Inwood 9th Avenue RFP Addendum

Addendum 1 Issue Date: November 27, 2024

Contents of the Addendum

1. Guidance on FAR generation assumptions

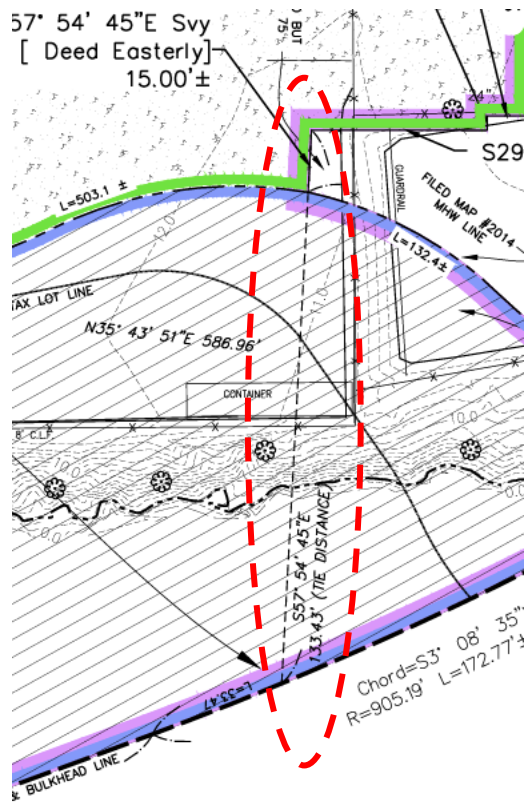
1. Respondents should not assume generation of FAR from any lot area within the future Waterfront Public Access Area north of the easterly prolongation of the southern line of lot 67 (approximately shown by the dashed line on the survey, circled below in red).
2. Respondents should assume full build out and maintenance of the WPAA in compliance with the New York City Zoning Resolution.
